Element 1. Proposed Authority approved methodologies and ESO guidance¹

Element 2. Introducing a bi-annual application window and two formal gates, which are known as Gate 1 and Gate 2 (i.e. the Primary Process)

Indicative Process Timeline (as set in in Annex 4)

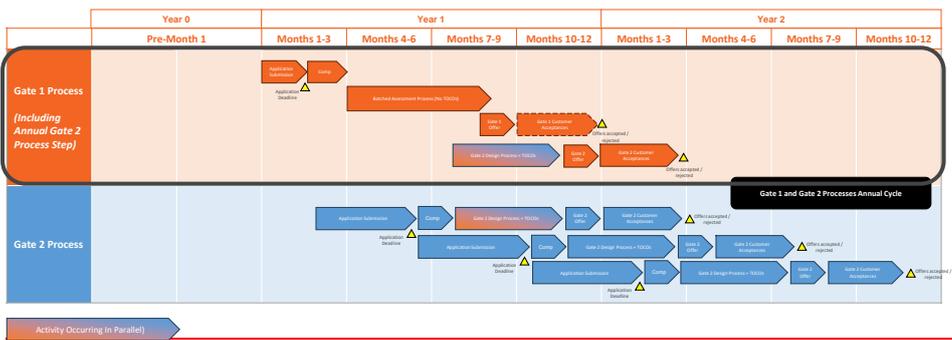
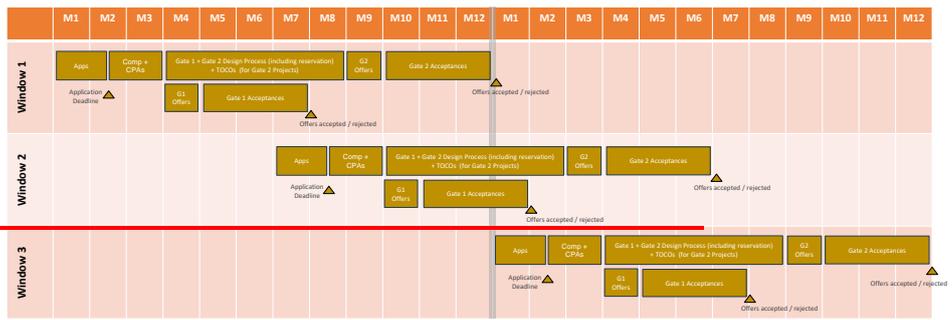
Commented [MO(5)]: To update.

Indicative Process Timeline (as set in in Annex 4)

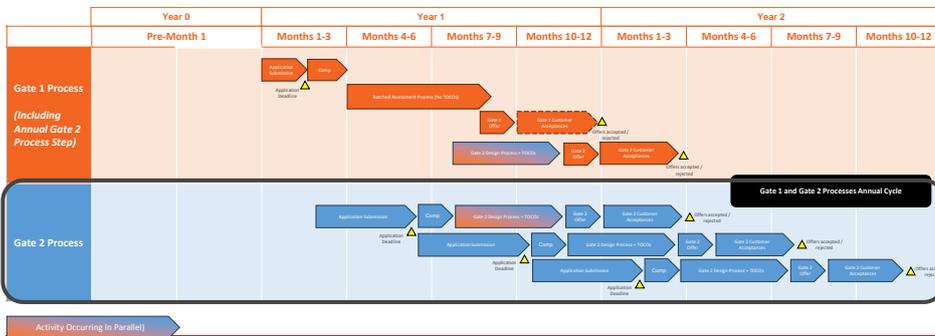
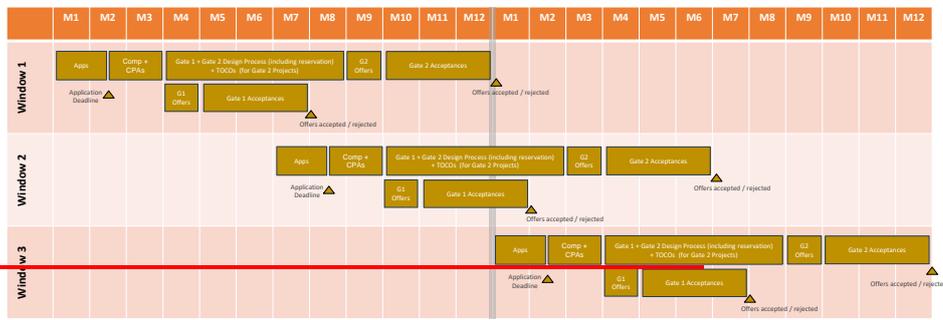
Commented [MO(8)]: To update.
